GFA AD 544
(ISSUE 1)

GFA AIRWORTHINESS DIRECTIVE

TYPE AFFECTED: Stemme S 10 and S 10-V. Serial Nos as follows -
S 10: 10-03 to 10-63;
S 10-V: 14-002 to 14-030 and 14.012M to 14-063M

**Airworthiness
Directive
2000-369**

Figure 1: New version 12TI-RD

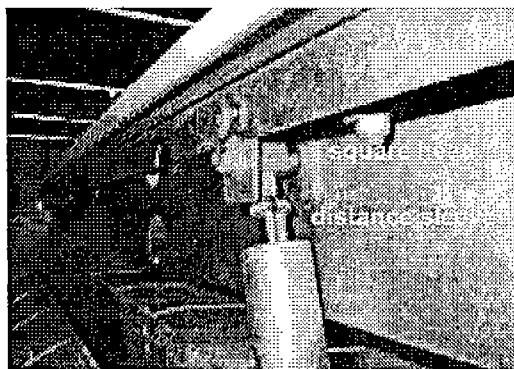
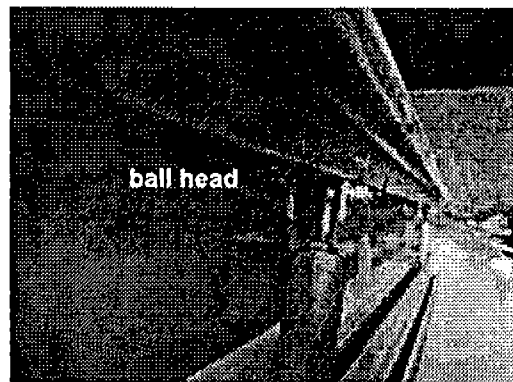
The feature that makes it possible to recognise these eye bolts (12TI-RD) based upon this Service Bulletin is a distance sleeve in the area of the screwing in the air brake lever and a square head. The "old" version has a ball head (refer to figure 1 and 2).

The eye bolts of air brakes 12TI-DB (Figure 2) and all of the fastening components belonging to it shall be exchanged with eye bolts of the 12TI-RD design (Figure 1) and their fastening components.

With the affected S/N s of action 1, the airspeed V_{NE} must be limited to 220 km/h (119 kts) until action 1 has been carried out. For this purpose, a „RED LINE“ shall be placed on the airspeed indicator at 220 km/h (119 kts).

After carrying out action 1, the „RED LINE“ (at 220 km/h) shall be removed again.
